NEW MEXICO
ENVIRONMENT DEPARTMENT

Hazardous Waste Bureau

August 6, 2010

**RE: BULK FUELS FACILITY SPILL, SWMUS ST-106 AND SS-111
DIRECTIVE FOR CONDUCTING INTERIM MEASURES AND NOTICE OF
DISAPPROVAL
INTERIM MEASURES WORK PLAN, JUNE 2010;
VADOSE ZONE WORK PLAN, JUNE 2010;
GROUNDWATER INVESTIGATION WORK PLAN, JUNE 2010
KIRTLAND AIR FORCE BASE, EPA ID# NM9570024423
HWB-KAFB-10-015, HWB-KAFB-10-016, HWB-KAFB-10-019**

Figure 1. Soil Boring and Soil-Vapor Monitoring Well Locations

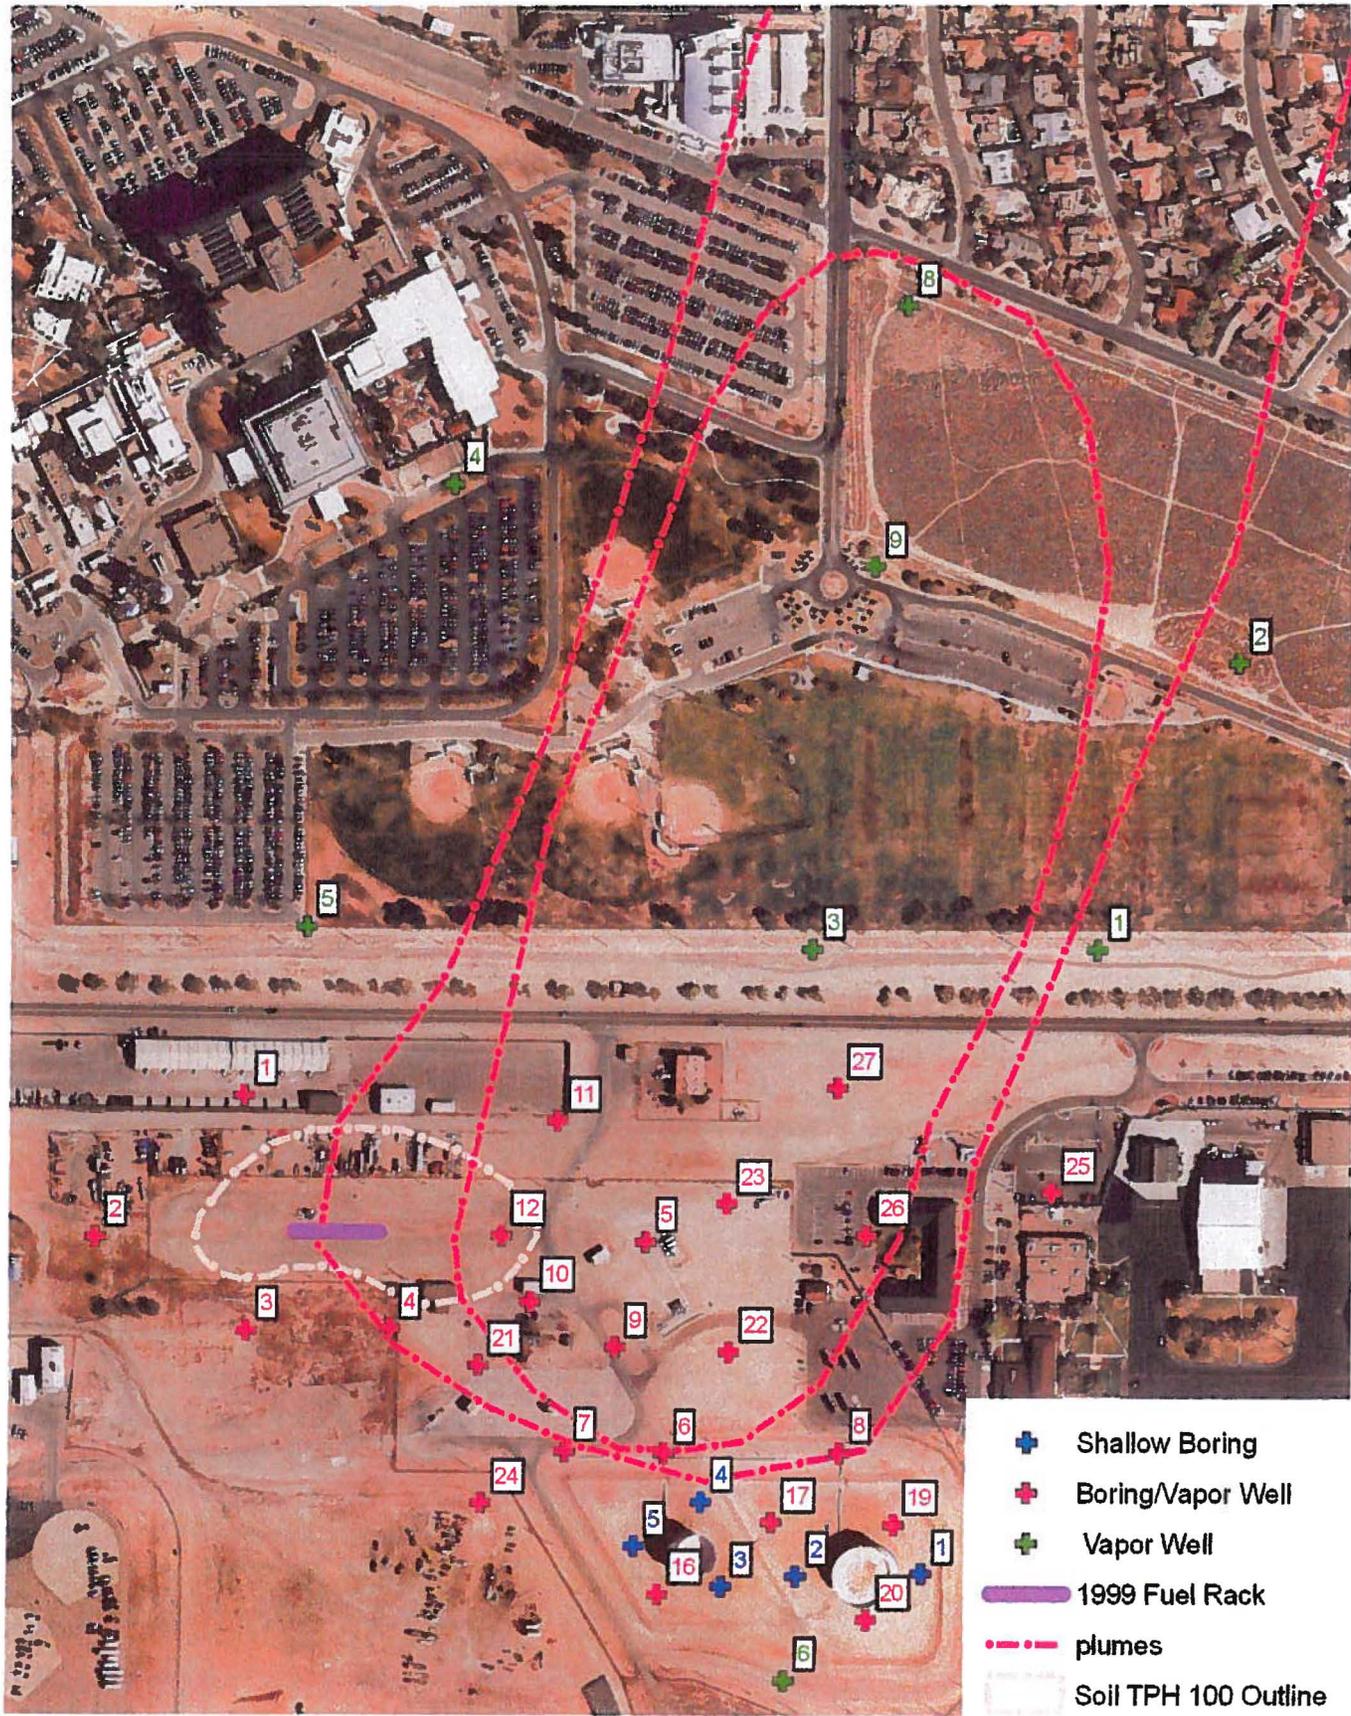
The Permittee shall complete the soil borings/soil-vapor wells at locations #16, 17, 19 and 20; and the soil vapor well at location #6 that are listed in Tables 1 and 2 of this letter, respectively, and shown on Figure 1 enclosed with this letter. The Permittee shall also complete shallow soil borings to a depth of at least 20 feet at locations #1 through 5, which are listed in Table 3 of this letter and shown also on Figure 1. Soil samples from the shallow borings shall be collected at depths of 0, 5, 10, 15, and 20 feet and shall be analyzed for TPH, VOCs, SVOCs, and lead.

The Permittee shall complete the deep soil borings/soil-vapor wells at locations #4, 6, 7, 8, and 24 that are listed in Table 1 of this letter and shown on Figure 1. The Permittee shall also complete shallow borings along the entire length of the pipeline between the tank farm and the Fuel Offloading Rack, regardless of whether the pipeline runs underground or on the surface. The borings shall be spaced at intervals not to exceed 25 feet and are to be located on both sides of the pipeline. Soil samples from the shallow borings shall be collected at depths of 0, 5, 10, 15, and 20 feet. The soil samples from deep and shallow borings shall be analyzed for TPH, VOCs, SVOCs, and lead. Depending on the results, NMED may require further investigation of this area, including more and deeper borings.

The Permittee did, however, propose an additional 3 deep soil sampling/vapor wells at locations further to the east. NMED agrees that these latter locations are necessary to properly characterize this area. Thus, to improve the understanding of the amount of fuel contamination in the vadose zone that must be remediated, the Permittee shall complete the soil borings/soil-vapor wells at locations #5, 9, 10, 21, 22, 23, 25, 26, and 27 listed in Table 1 and shown on Figure 1.

5. Far field area of Soil-Vapor plume – In its letter of April 2, 2010, NMED directed the Permittee to install six soil-vapor wells at locations north of the Fuel Offloading Rack and fuel percolation area to investigate the concentrations of hazardous constituents in soil gas that overlies groundwater in these areas. The Permittee shall complete the soil-vapor wells at locations #1, 2, 4, 3, 5, 6, 8, and 9; and the soil boring/soil-vapor well at location #24, that are listed in Tables 2 and 1, respectively, and shown on Figure 1.

Figure 2. Groundwater Monitoring Well Locations

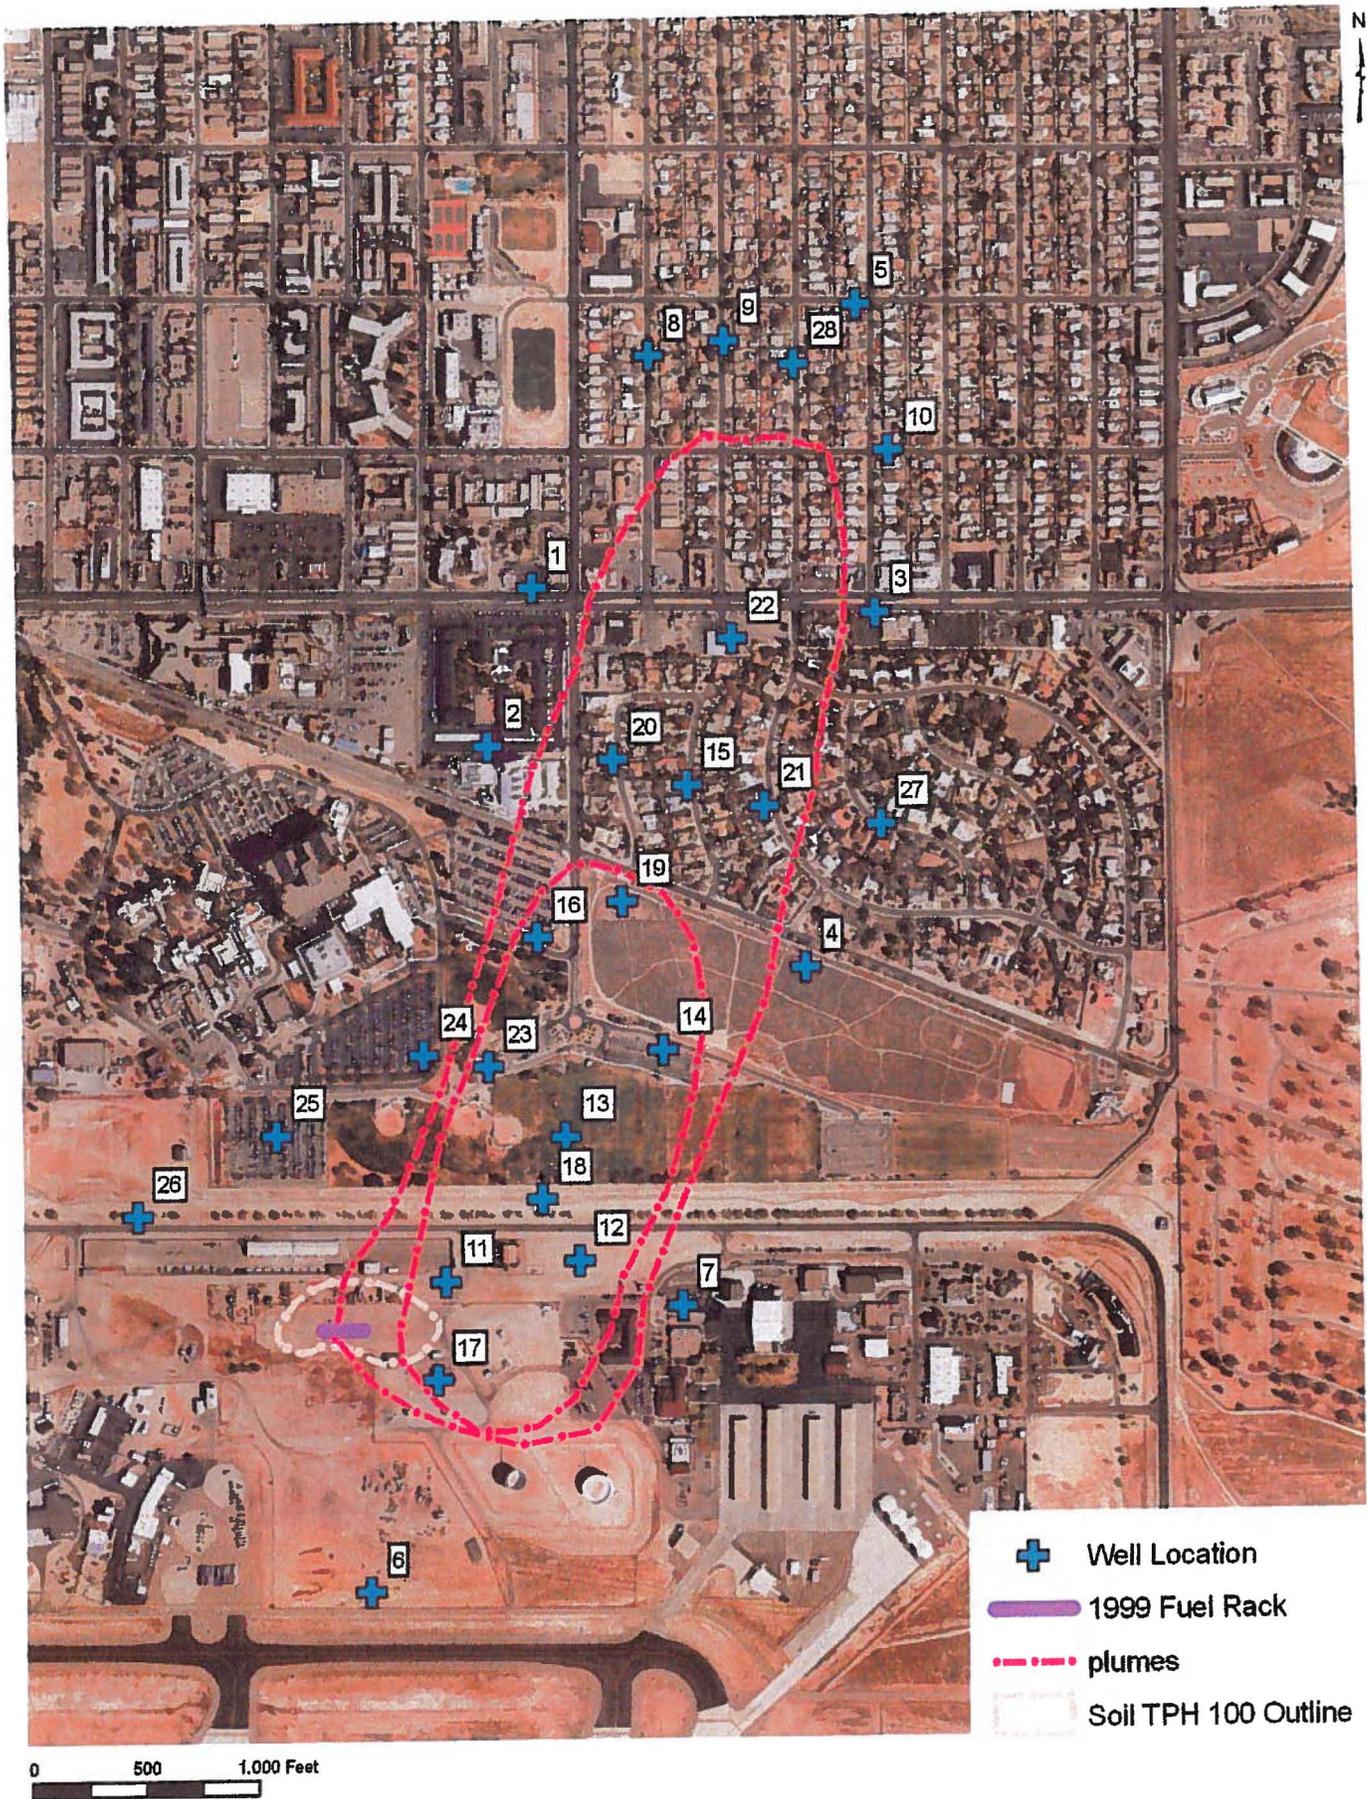
1. Background Water Quality - Only two upgradient wells have been installed that potentially may yield groundwater samples that are free from contamination. Both of these wells were only recently completed; none is screened appreciably below the water table to provide vertical characterization of water quality, geology, and hydrologic conditions. The Permittee must complete the background cluster/nested wells at location #6 listed in Table 4 of this letter and shown on Figure 2 (enclosed).

To achieve the objective of providing initial plume-core characterization, the Permittee shall install the groundwater monitoring wells at locations #11, 12, 13, 14, 15, 16, 17, 18, 19, 20, 21, 22, and 23 listed in Table 4 and shown on Figure 2.

To adequately provide initial plume-edge characterization, the Permittee shall install the groundwater monitoring wells at locations #1, 2, 3, 4, 5, 7, 8, 9, 10, 24, 25, 26, 27, and 28 that are listed in Table 4 and shown on Figure 2.

Figure 3 Existing Soil Boring, Soil-Vapor Monitoring Well and Cross-Section Locations

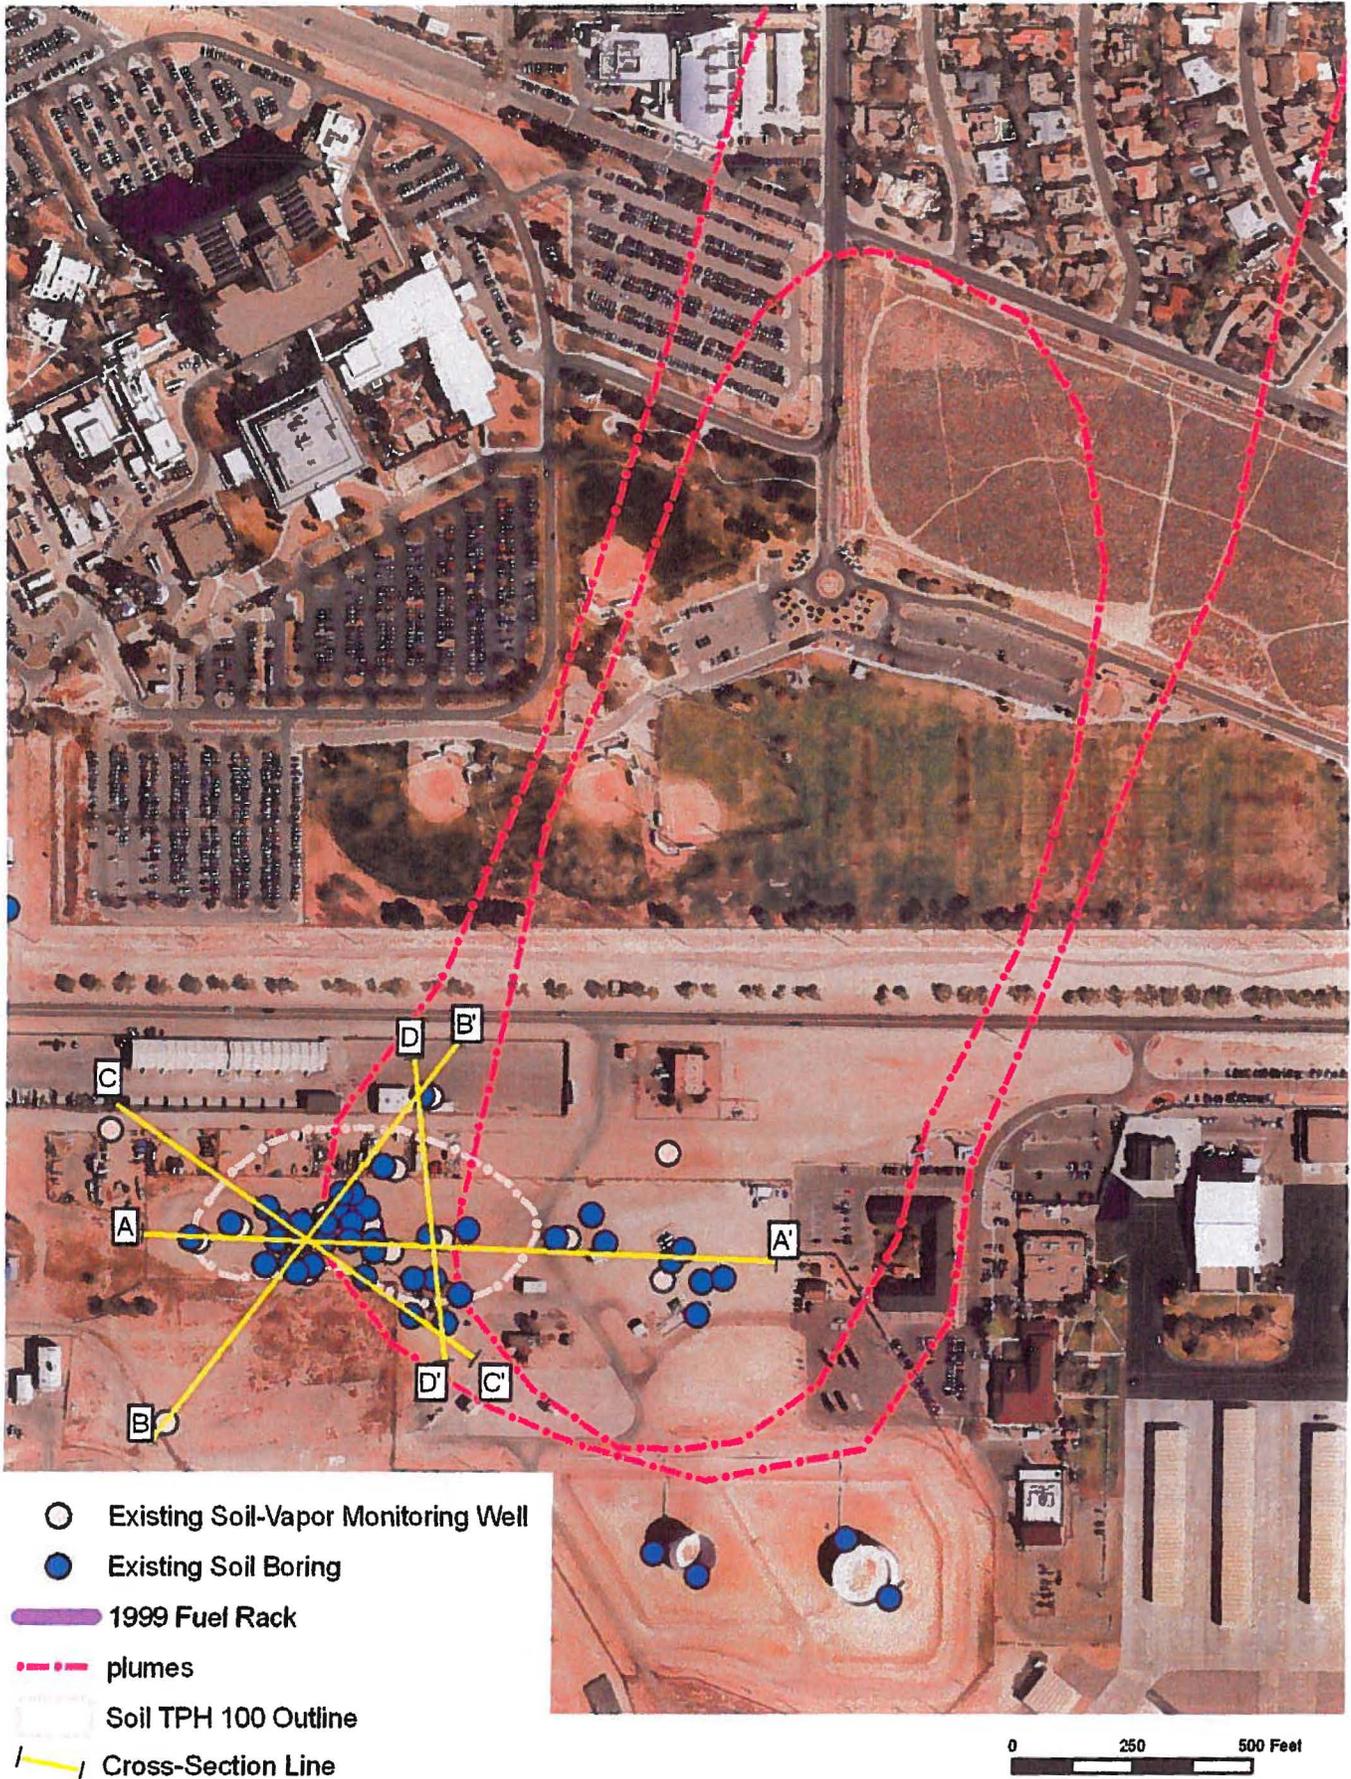
- v. Cross-sections showing the geology of the site drawn to a horizontal scale of 1 inch equals 50 feet, a vertical scale of 1 inch = 50 feet, and along the orientations A-A', B-B', C-C', and D-D' as shown on Figure 3 enclosed with this letter.

- vii. Cross-sections showing concentrations of major hazardous constituents in soil, drawn to a horizontal scale of 1 inch equals 50 feet, a vertical scale of 1 inch = 50 feet, and along the orientations A-A', B-B', C-C', and D-D' as shown on Figure 3 enclosed with this letter.

- viii. Cross-sections showing concentrations of major hazardous constituents in soil vapor, drawn to a horizontal scale of 1 inch equals 50 feet, a vertical scale of 1 inch = 50 feet, and along the orientations A-A', B-B', C-C', and D-D' as shown on Figure 3 enclosed with this letter.

Figure 4. Existing Well and Cross-Section Locations

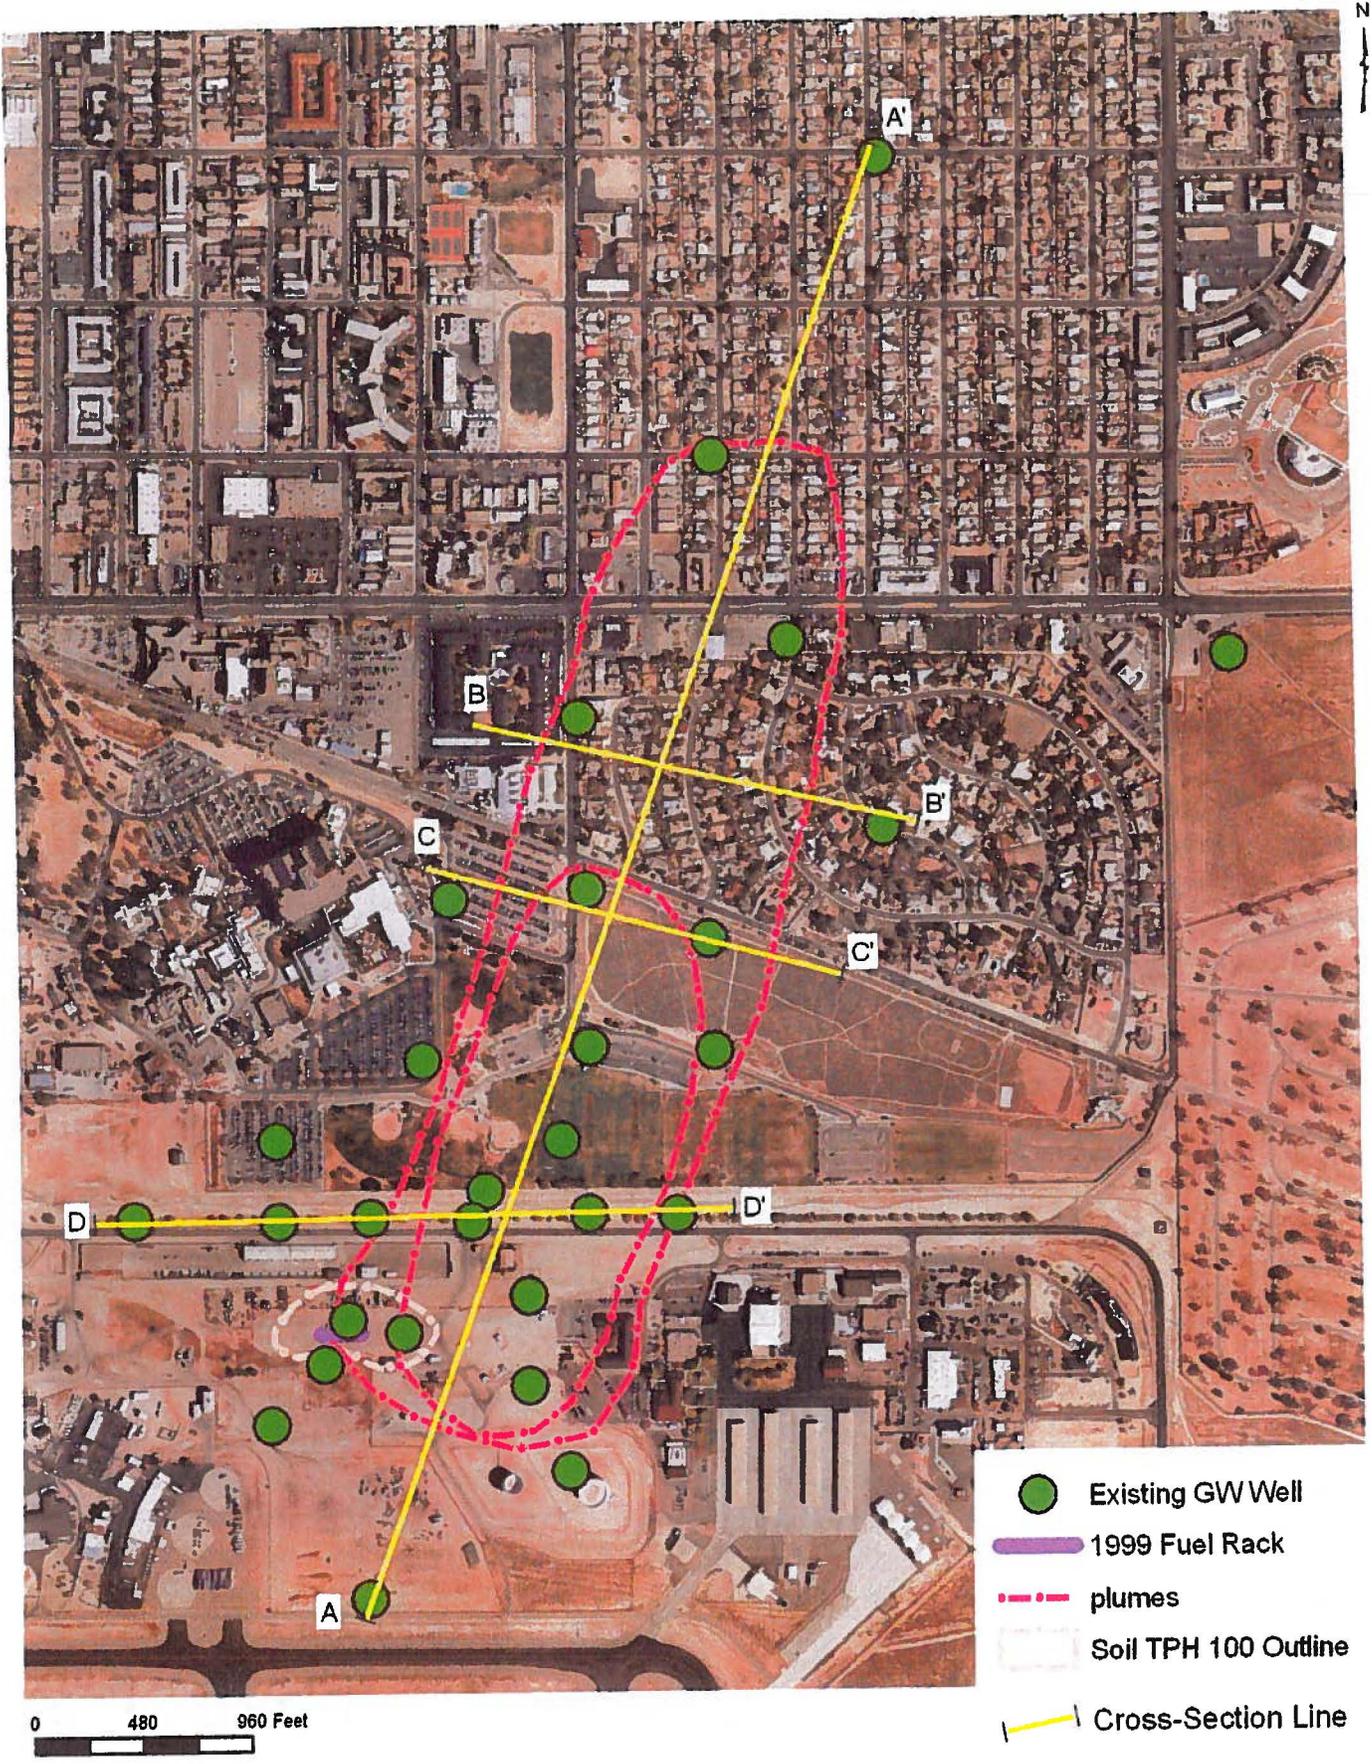
- vi. Cross-sections showing the geology of the site drawn to a horizontal scale of 1 inch equals 300 feet, a vertical scale of 1 inch = 50 feet, and along the orientations A-A', B-B', C-C', and D-D' as shown on Figure 4 enclosed with this letter.

- ix. Cross-sections showing concentrations of major hazardous constituents in groundwater, drawn to a horizontal scale of 1 inch equals 300 feet, a vertical scale of 1 inch = 50 feet, and along the orientations A-A', B-B', C-C', and D-D' as shown on Figure 4 enclosed with this letter.
